BURLINGTON INTERNATIONAL AIRPORT

**TERMINAL INTEGRATION PROJECT**

ADDENDUM NO. 5

July 31, 2020

## WALL LOUVER/CONTROL DAMPER DETAIL

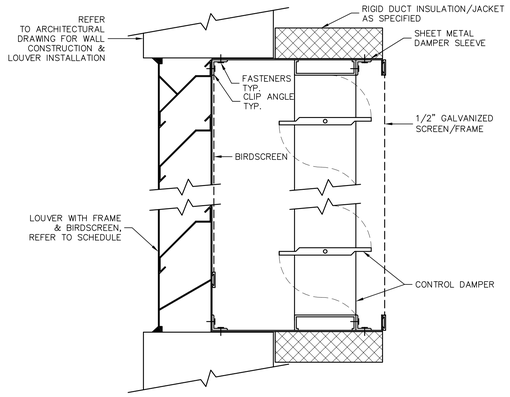
**Question:** Reference "View 2 – Workshop; South Apron" image that was released in addendum #2. There is an existing louver that looks to be located above the Maintenance Office 109. Please advise what this louver serves as there is no indication upon review of the existing south terminal reference drawings H1.1 and H2.2.

***Response:*** *This louver is part of the ventilation system for the chiller upgrade completed in 2010. The design drawings for this system are attached to this Addendum.*
